UNITED STATES
NUCLEAR REGULATORY COMMISSION
WASHINGTON, D. C. 20555

The Commission has issued the enclosed Amendment No. 88 to Facility Operating License No. DPR-58 for the Donald C. Cook Nuclear Plant, Unit No. 1. The amendment consists of changes to the Technical Specifications in response to your applications transmitted by letters dated July 18, 1985 and July 19, 1985 and supplemented by letter dated July 3, 1985.

DONALD C. COOK NUCLEAR PLANT UNIT NO. 1

Amendment No. 88
License No. DPR-58

Figure 3.4-2

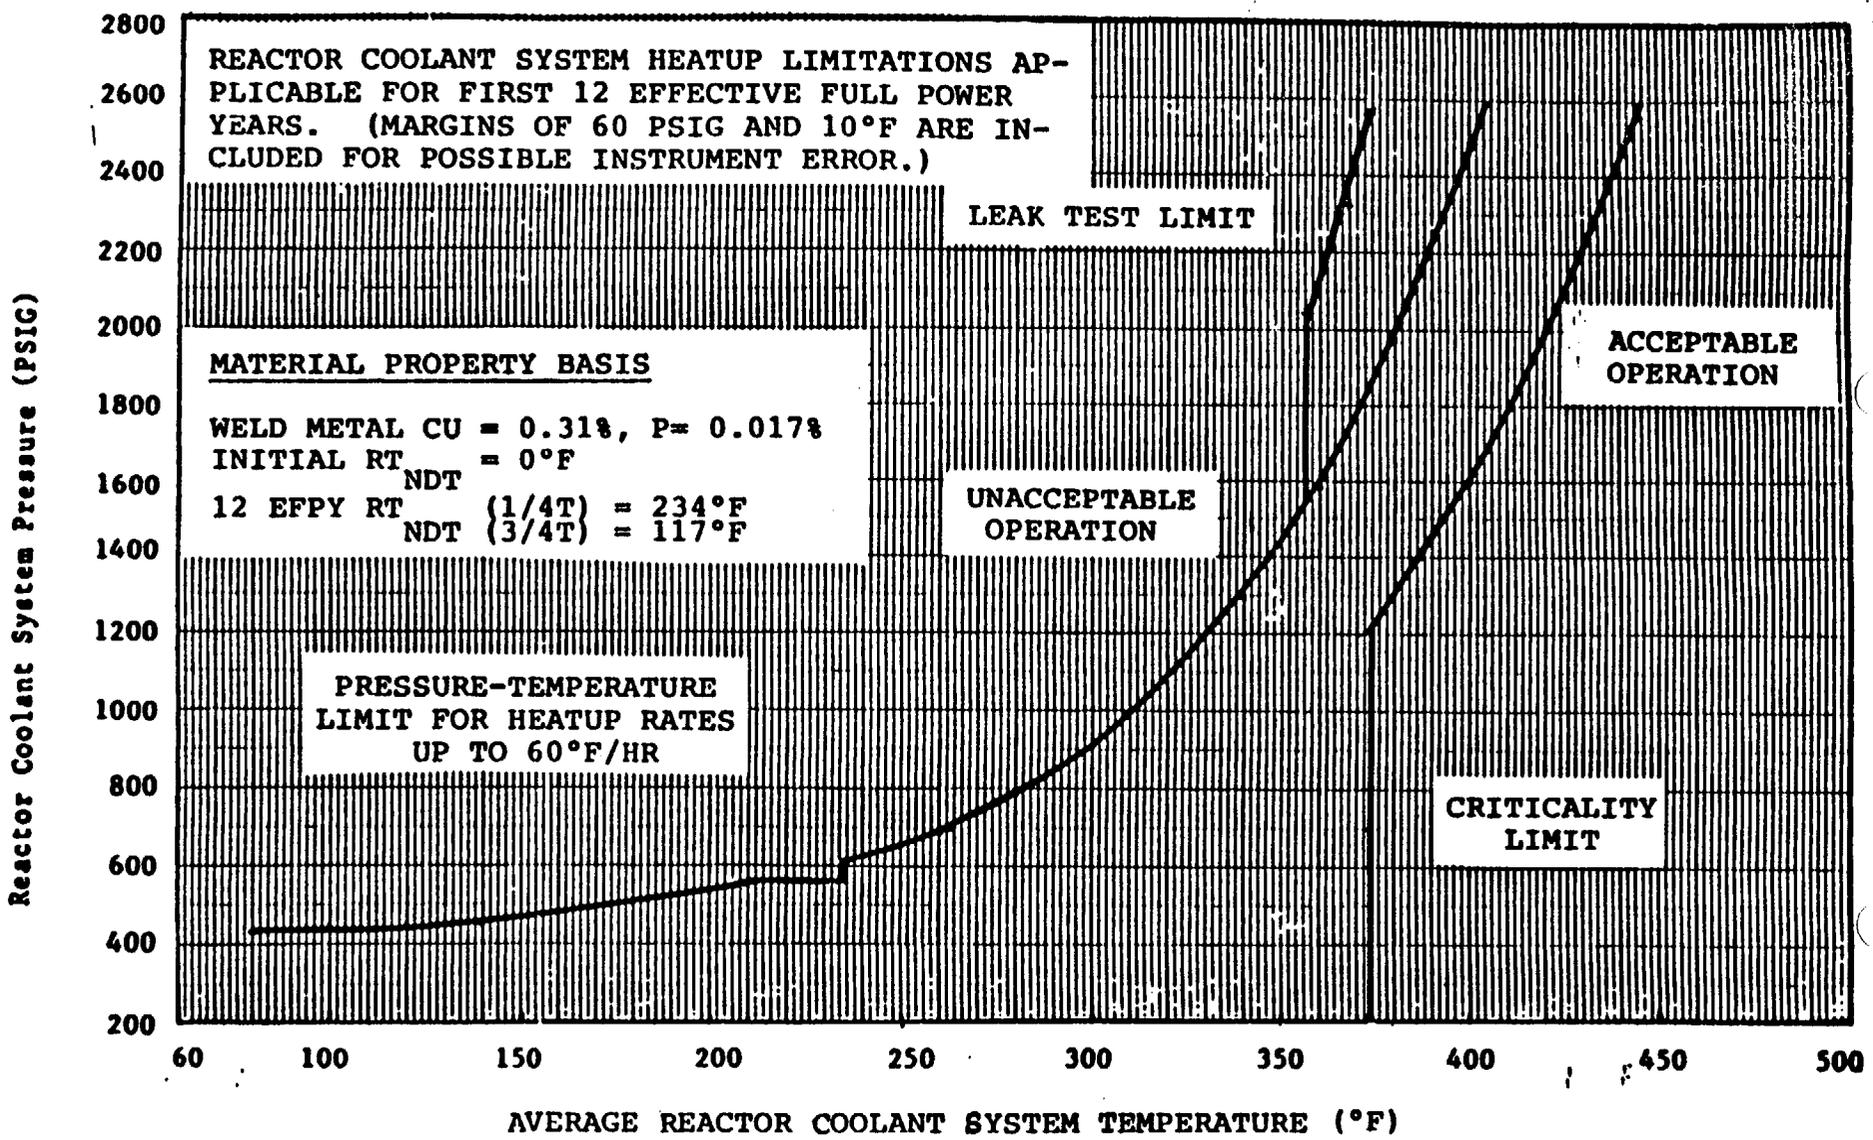
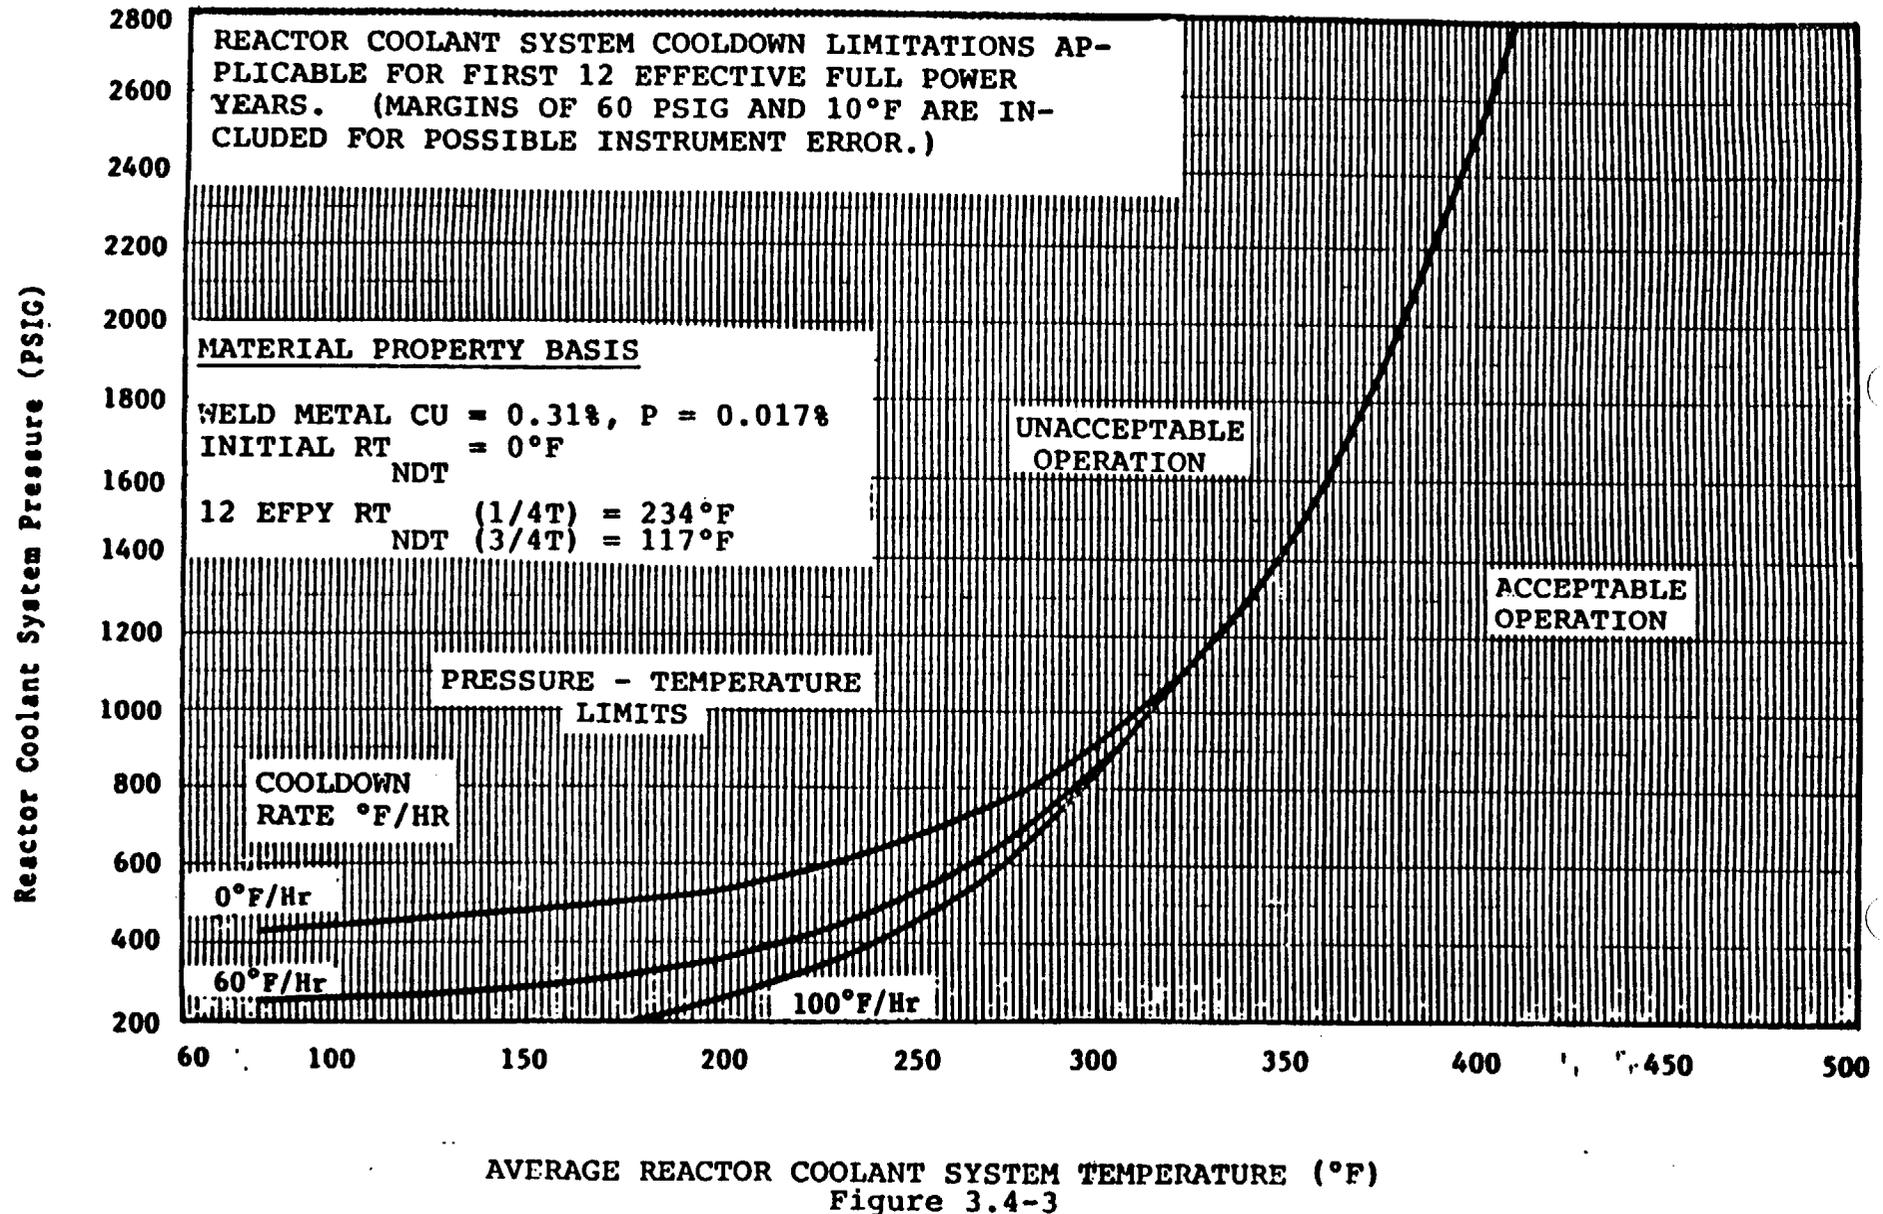
The amendment revises the Technical Specifications to account for heatup and cooldown, and low temperature (cold) overpressure protection through twelve effective full power years of reactor operation.

The heatup limit curve, Figure 3.4-2, is a composite curve which was prepared by determining the most conservative case, with either the inside or outside wall controlling, for any heatup rate up to 60°F per hour. The cooldown limit curves of Figure 3.4-3 are composite curves which were prepared based upon the same type analysis with the exception that the controlling location is always the inside wall where the cooldown thermal gradients tend to produce tensile stresses while producing compressive stresses at the outside wall. The heatup and cooldown curves were prepared based upon the most limiting value of the predicted adjusted reference temperature at the end of 12 EFY.

Reactor operation and resultant fast neutron ($E > 1$ Mev) irradiation will cause an increase in the RT_{NDT} . Therefore, an adjusted reference temperature, based upon the fluence and copper and phosphorus content of the material must be predicted. The heatup and cooldown limit curves of Figures 3.4-2 and 3.4-3 include predicted adjustments for this shift in RT_{NDT} at the end of 12 EFY, as well as adjustments for possible errors in the pressure and temperature sensing instruments.

The pressure-temperature limit lines shown on Figure 3.4-2 for reactor criticality and for inservice leak and hydrostatic testing have been provided to assure compliance with the minimum temperature requirements of Appendix G to 10 CFR 50.

The surveillance report for Capsule Y was used as the source of the fluence value. The reported calculated maximum fluence at the vessel I.D. surface was 3.6×10^{18} n/cm² (E > 1 MeV), corresponding to 4.94 EFPY. There being no announced plans for flux reduction, these numbers were ratioed and multiplied by 12 to obtain an I.D. surface fluence of 8.8×10^{18} n/cm² for the desired period of serviceability of the new P-T limits (12 EFPY). We accept this value as the basis for the calculation of P-T limits.

To calculate RT_{NDT} , the proposed revised Technical Specifications reference the surveillance report for Capsule Y, prepared by Southwest Research Institute (SRI), and the methods found acceptable by Regulatory Guide 1.99, Revision 1. This is a satisfactory basis. In our check of the P-T limits, we used both Revision 1 and some more recent information collected to provide a basis for updating Revision 1. We found the two were in agreement within $\pm 10^\circ\text{F}$. To clarify the basis for calculating the RT_{NDT} , the licensee at our request submitted revised bases pages B 3/4 4-6 thru 4-11. The submittal dated August 1, 1985 contains no new information on the proposed amendment. The revised pages are acceptable.

In conclusion, the staff has used the method of calculating pressure-temperature limits in USNRC Standard Review Plan 5.3.2, NUREG-0800, Rev. 1, July 1981 to evaluate the proposed pressure-temperature limits. The amount of neutron irradiation damage to the limiting beltline material was calculated using the method recommended in Regulatory Guide 1.99, Revision 1. Our conclusion is that the proposed pressure temperature limits meet the safety margins of Appendix G, 10 CFR 50 for twelve (12) EFPY and may be incorporated into the Unit-1 technical specifications.
